Document 00 20 00 - Addendum No. 1

DATE: November 24, 2025

SUBJECT: ADDENDUM NO. 1 TO THE BIDDING DOCUMENTS FOR

SE878E Woodland Lodge - Woodland HVAC and Roof Replacement
Indiana University Southeast
IU 20251224

M601

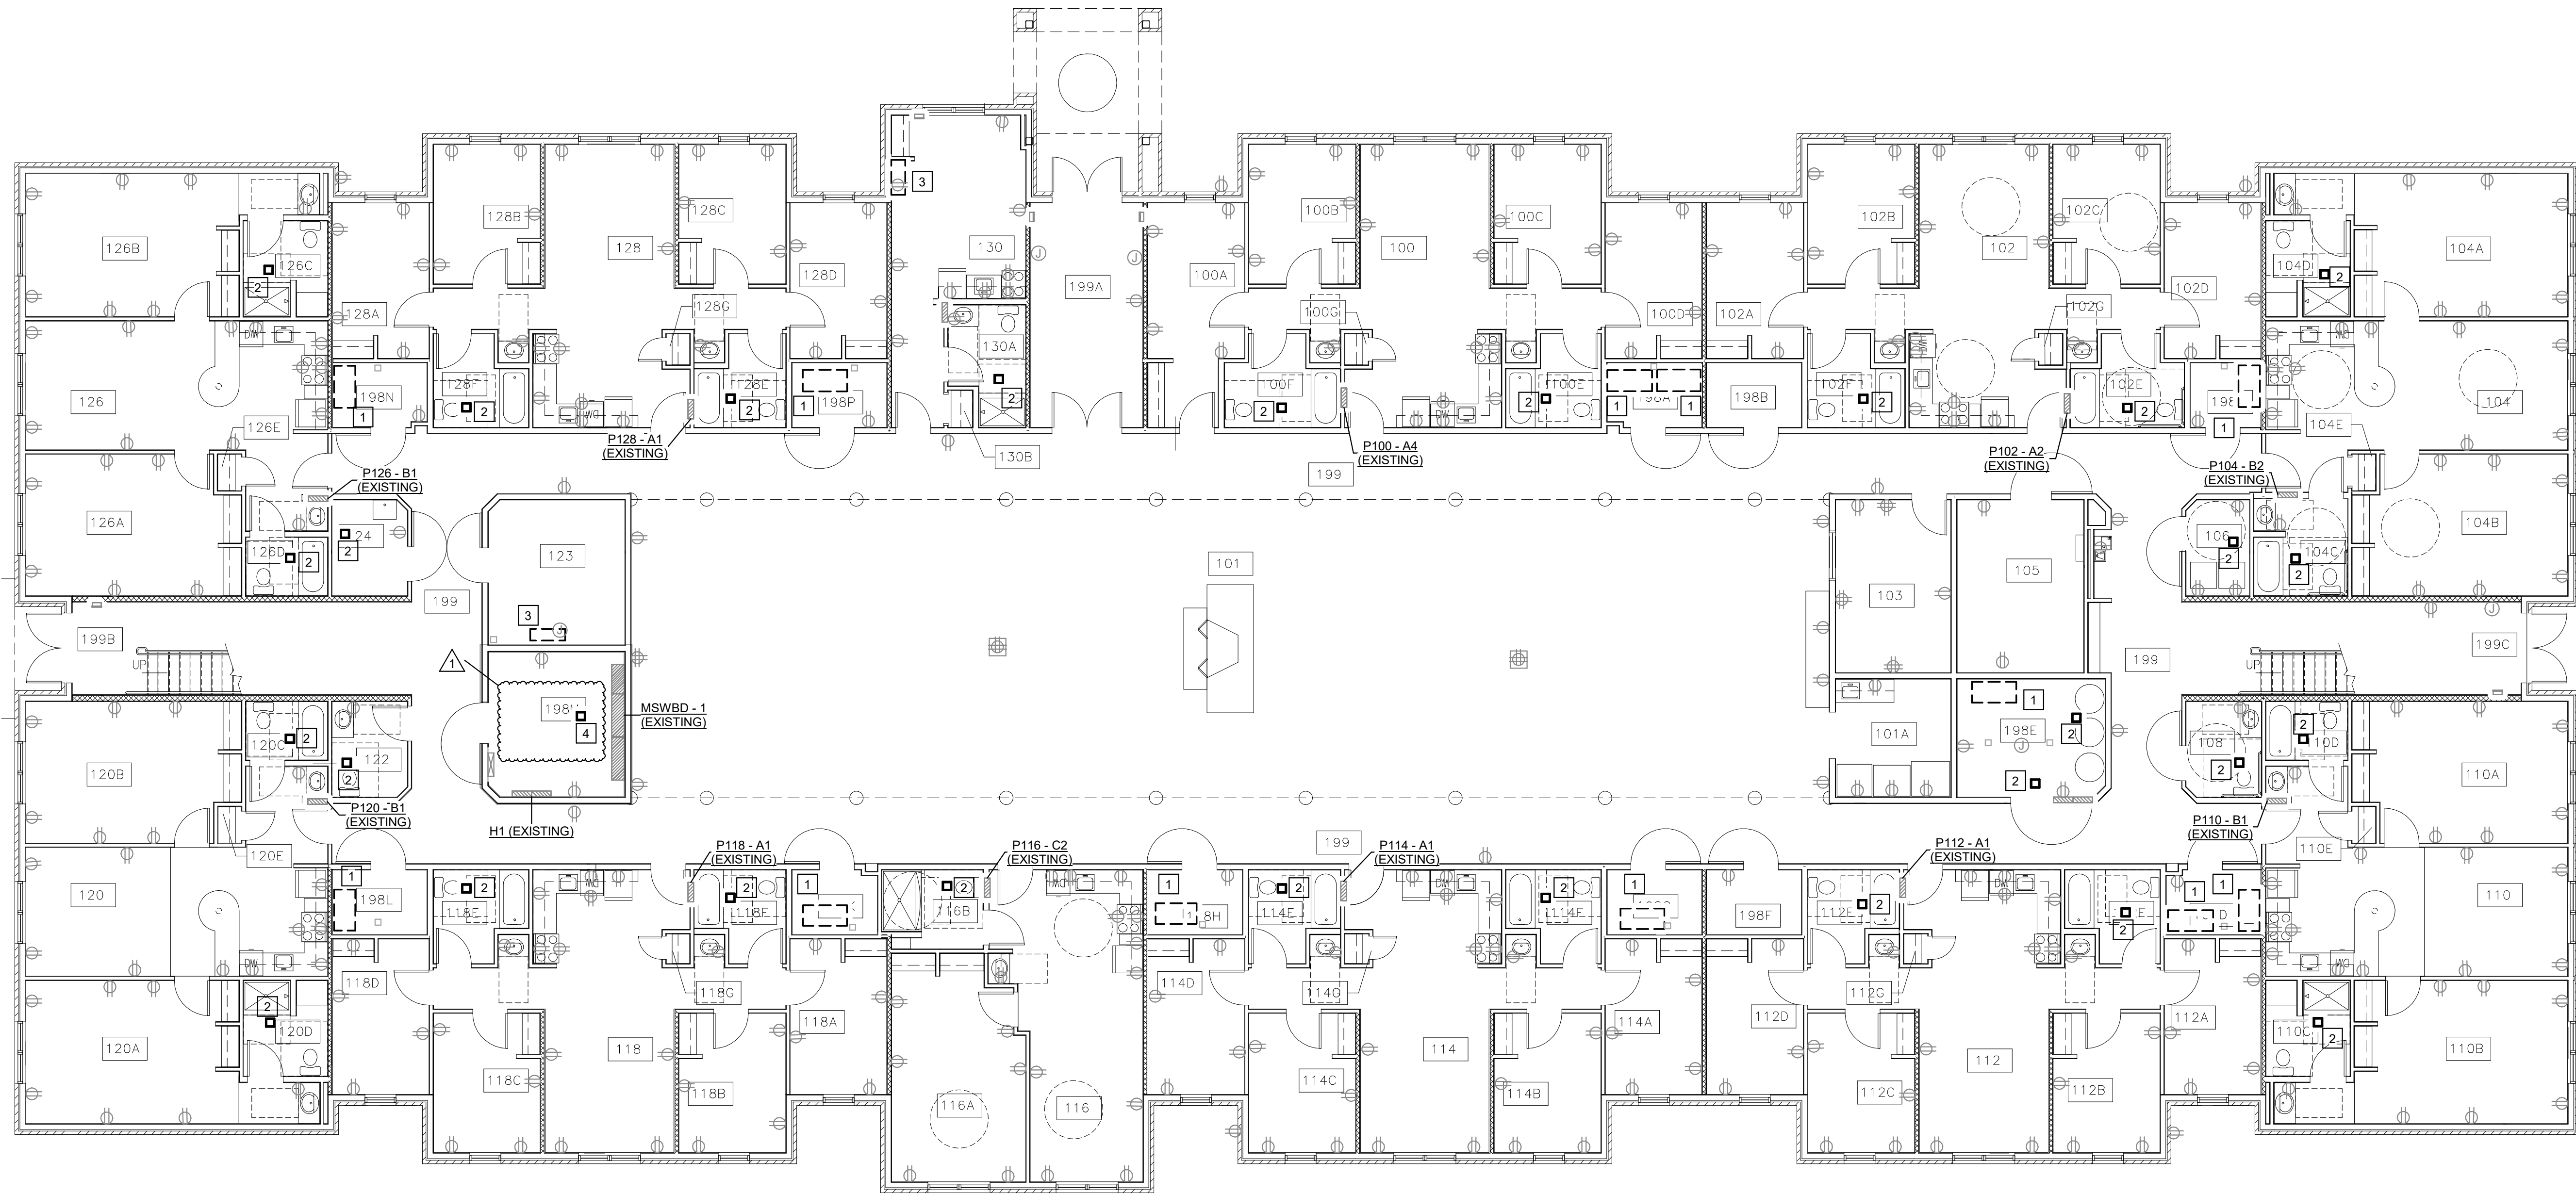
6. Sheet M601 – AIRFLOW DIAGRAM:
 - a. Updated “ERU-1 AIRFLOW DIAGRAM” as indicated on the attached.
7. Sheet ED301 – FIRST FLOOR ELECTRICAL DEMOLITION PLAN – POWER:
